BVH ARCHITECTURE

ADDENDUM NO.: #01

DATE: 01/31/2024

PROJECT: Woodhouse Ford Pro: Building Improvements

1 FLOOR PLAN - PLUMBING - AREA C

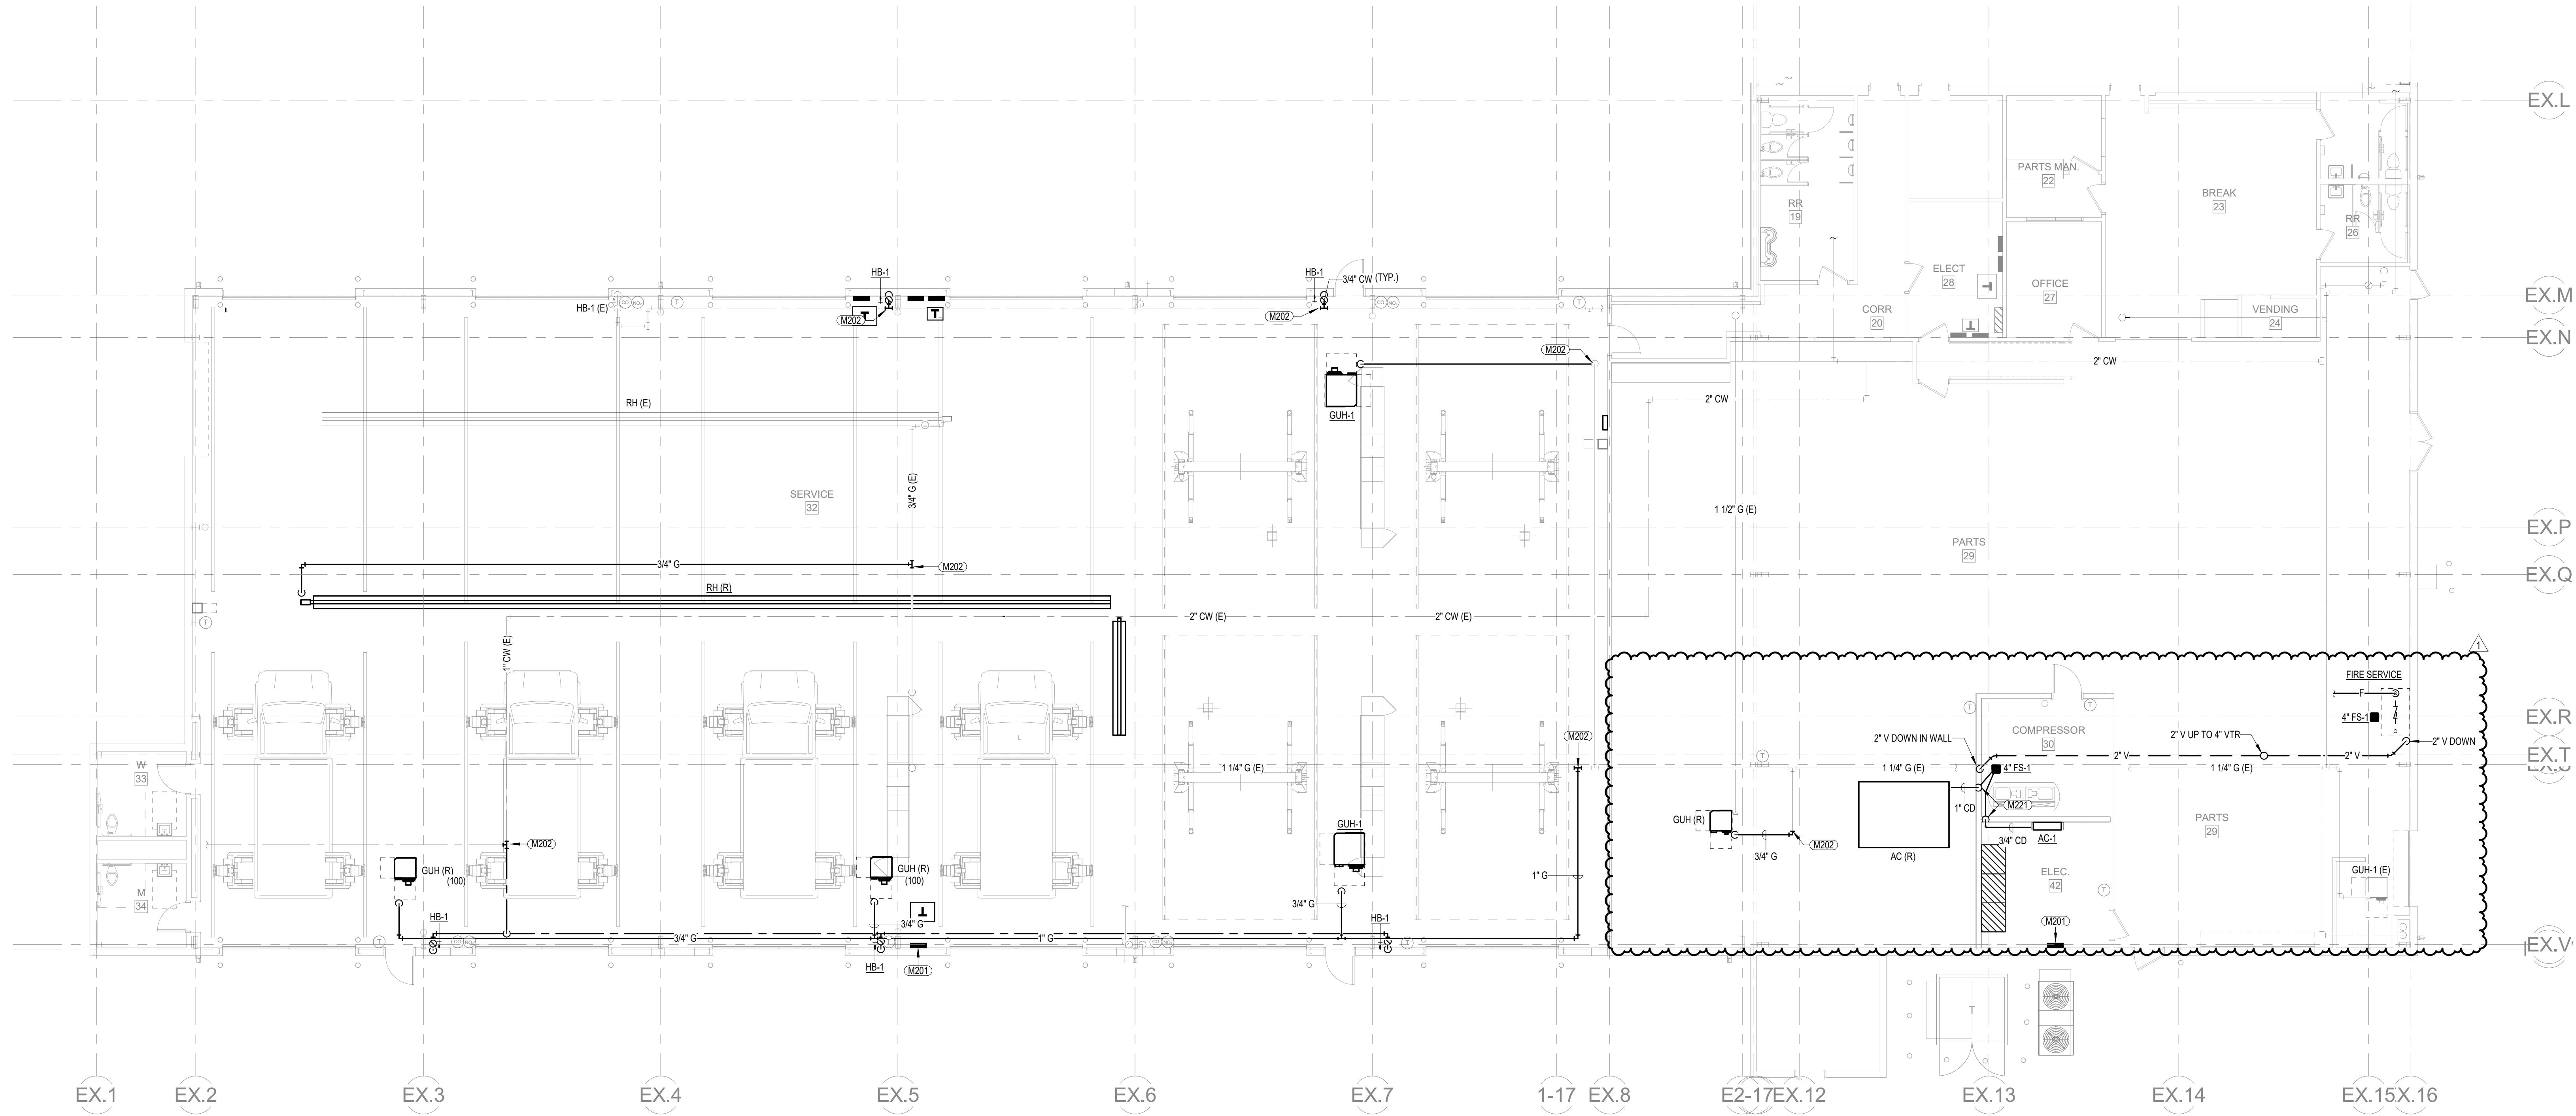
- a. Add gas piping for relocated unit heater.
 - b. Add condensate piping for relocated ac unit and new AC-1 serving Elec 42.
8. Sheet M3.2 – MECHANICAL DETAILS
- a. Add split system detail
9. Sheet M4.1 – MECHANICAL SCHEDULES
- a. Add refrigerant and condensate piping to pipe insulation schedule.
 - b. Add split system air conditioning unit schedule.
10. Mechanical Specifications:
- a. Section 233423 Power Ventilators
 - i. Add Soler & Palau to list of allowable manufacturers.
 - b. Section 235523 Gas-Fired Radiant Heaters
 - i. Add Re-Verber-Ray to list of allowable manufacturers.
 - c. Section 233113 Metal Ducts and Accessories
 - i. Add Louvers & Dampers Inc. to list of allowable manufacturers.

**FLOOR PLAN -
 LIGHTING - AREA A**

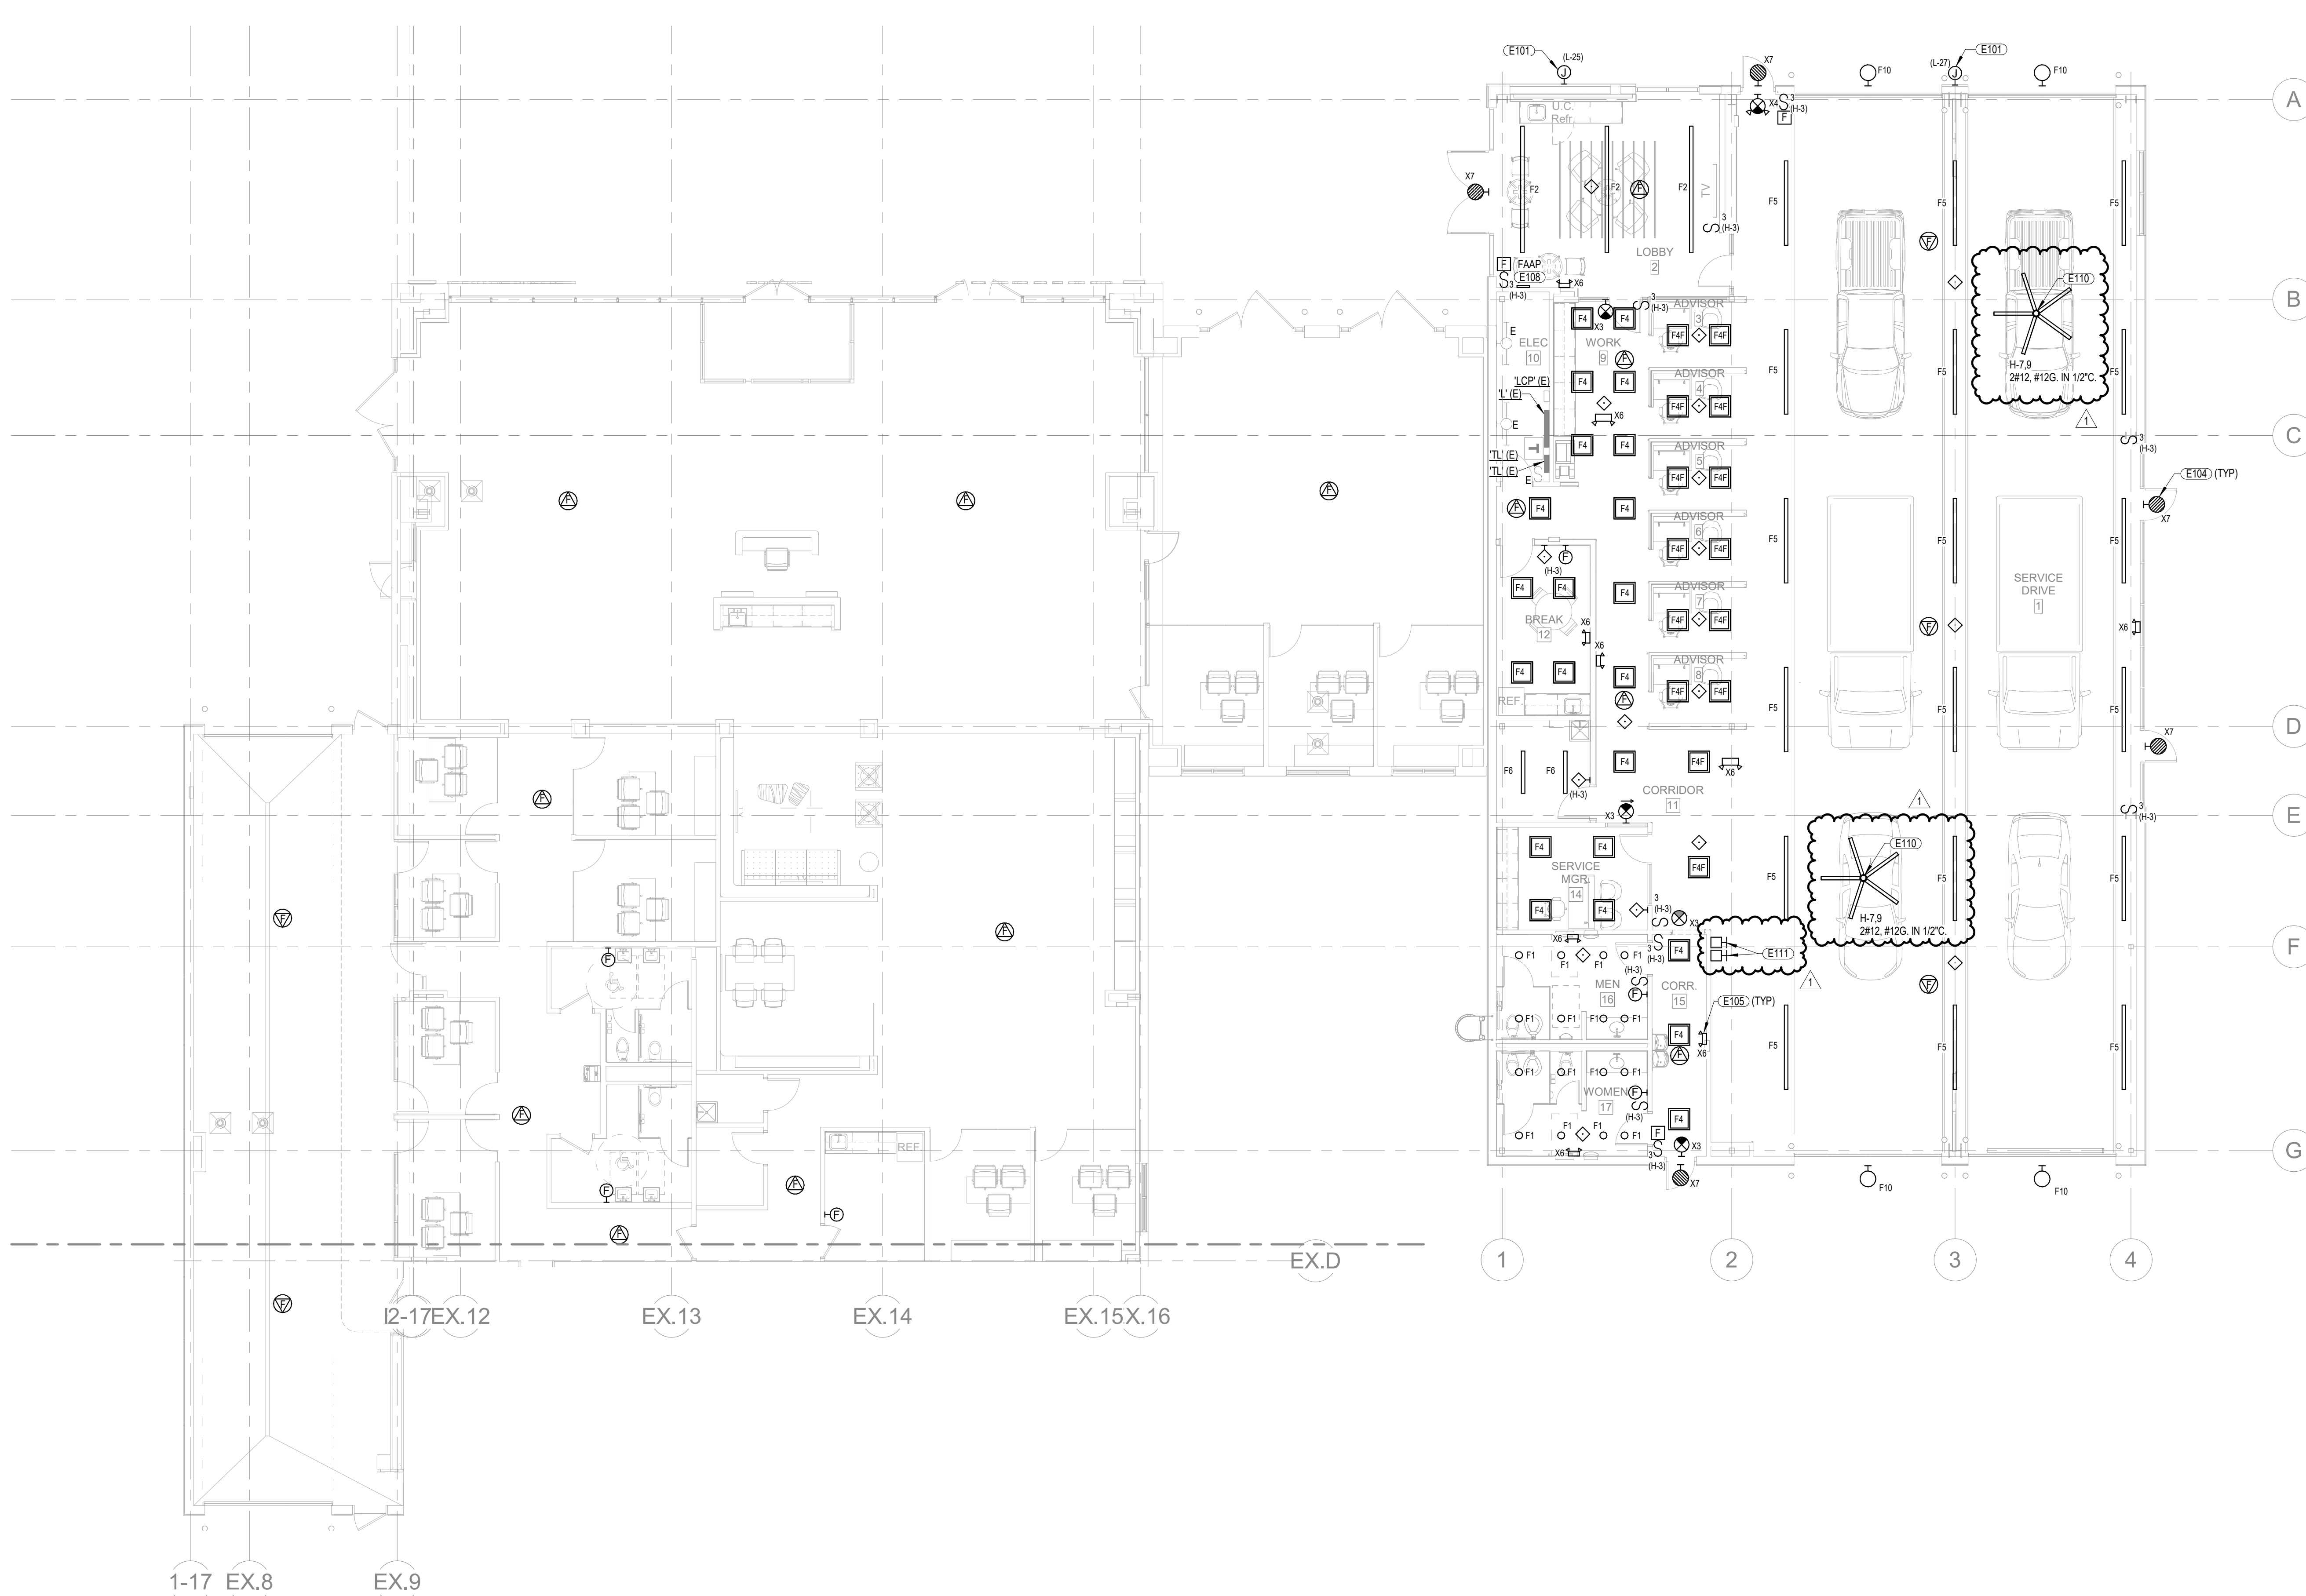
- 1. Sheet E1.1 – FLOOR PLAN – LIGHTING – AREA A
 - a. Add HVLS fans and controllers.
 - b. Revise Keynotes
- 2. Sheet E1.3 – FIRST FLOOR PLAN – LIGHTING – AREA C
 - a. Add HVLS fans and controllers.
 - b. Revise Keynotes
- 3. Sheet E2.3 – FIRST FLOOR PLAN – POWER – AREA C
 - a. Add cord reels in Service 32
 - b. Extend existing circuits to relocated mechanical equipment in Parts 29
 - c. Add electrical connection to AC-1 in Electrical Room 42.
- 4. Sheet E2.6 – ROOF PLAN – POWER – AREA C
 - a. Add connection to HP-1.
- 5. Sheet E4.0 – ELECTRICAL SCHEDULES AND DIAGRAMS
 - a. Mechanical Connection Schedule – Add AC-1 and HP-1
- 6. Sheet E4.1 – ELECTRICAL PANEL SCHEDULES
 - a. Revise circuit breakers in Panel S1.
 - b. Revise circuit breakers in Panel H2.
 - c. Revise circuit breakers in Panel A1.
 - d. Revise circuit breakers in Panel H.

- E106 PROVIDE 10" DOWNHIT TO FAN
- E110 PROVIDE HVLS FAN, HUNTER ECO SERIES, 8 FT DIAMETER, 300V, 1 PHASE WITH VARIABLE SPEED DIGITAL TOUCH SCREEN CONTROLLER. PROVIDE WITH ALL MOUNTING ACCESSORIES REQUIRED FOR A COMPLETE INSTALLATION. FIELD VERIFY FAN LOCATION AND MAINTAIN ALL REQUIRED CLEARANCES.
